34 Fouche Avenue, Old Beach TAS 7017

Proposal: Unit Development

Re: Planning Permit Application - DA2022/00169 - Multiple Dwellings (2) - 34 Fouche Avenue, Old Beach

In response to the request for further information received 11.08.22 we have addressed the information requested with the following:

Pg. No: A0.04

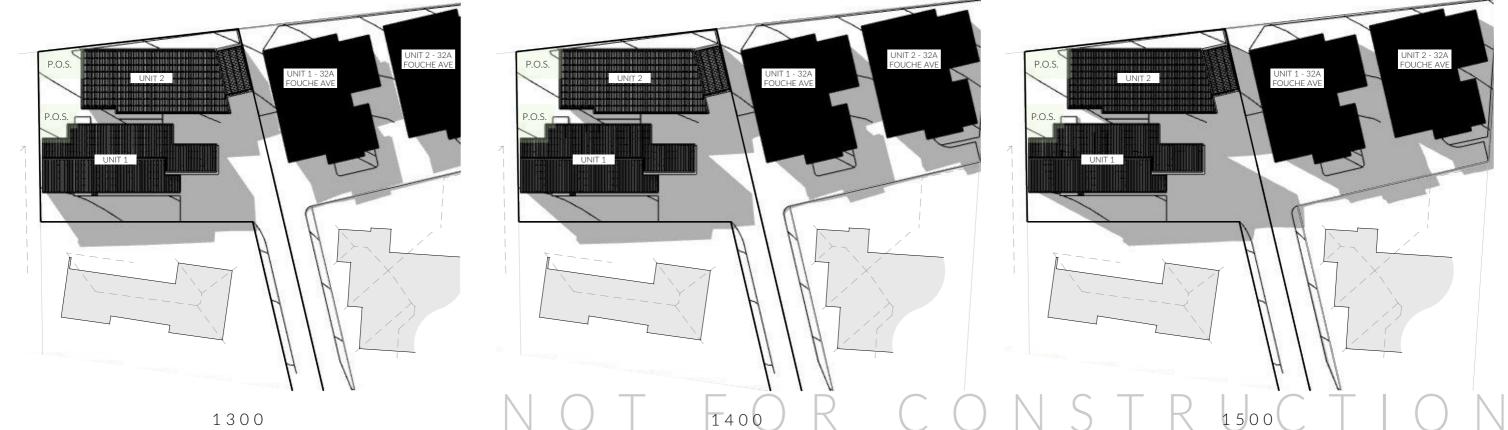
- (a) not cause an unreasonable loss of amenity to adjoining properties, having regard to:
 - (i) reduction in sunlight to a habitable room (other than a bedroom) of a dwelling on an adjoining property;
 - (ii) overshadowing the private open space of a dwelling on an adjoining property;
 - (iii) overshadowing of an adjoining vacant property; or
 - (iv) visual impacts caused by the apparent scale, bulk or proportions of the dwelling when viewed from an adjoining property; and
- (b) provide separation between dwellings on adjoining properties that is consistent with that existing on established properties in the area.

Please refer to sheet A0.04 for building envelope diagrams. You will see the only part that of the development that does not comply is a small section of roof on the western side of unit 1.

A0.06

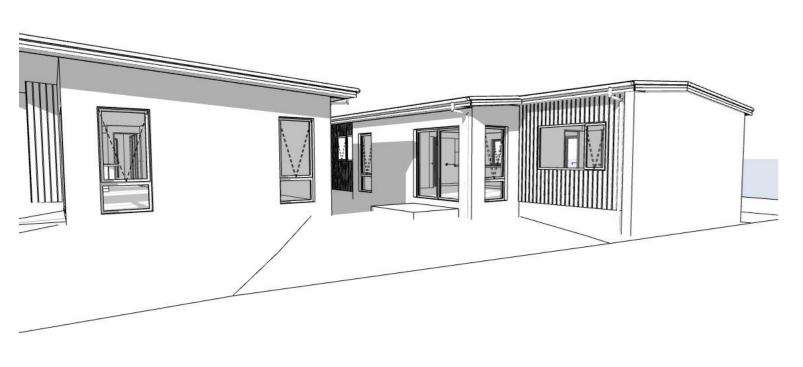
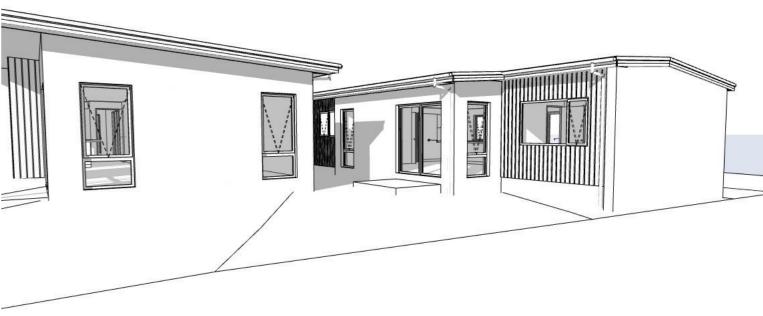
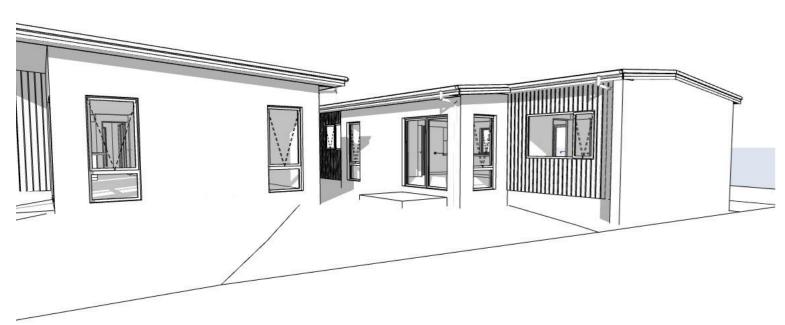
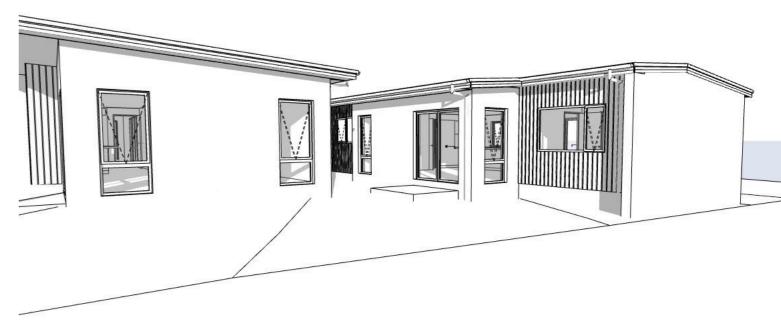
Clause	Council Request	Response
C8.4.2	 1.1. Please provide amended shadow diagrams also showing the proposed units at 32A Fouche Avenue with their respective floor plan; and 1.2. Please provide a more detailed response to clause 8.4.2 P3 of the planning 	Please refer to the revised drawing set DA-02, showing amended shadow diagrams (A0.05) with inclusion of the proposed units at 32A Fouche Avenue. The diagrams indicate minor impacts on the proposed developments on this neighbouring property, with no overshadowing during the hours of 9:00 and 12:00
	scheme	The performance criteria (P3) of C8.4.2 have been addressed as follows:

Additional shadow diagrams have also been included (refer to A0.06) in the revised drawing set DA-02, demonstrating that there is no impact between 12:00 and 15:00 on June 21st from Unit 2 to D01 & W02 of Unit 1, which are the more critical apertures to the penetration of direct sun to the living area of Unit 1. While there are some impacts to W03 between the hours stated above, there is some direct sun during this period, with approximately 50% of W03 in full sun by 14:00.
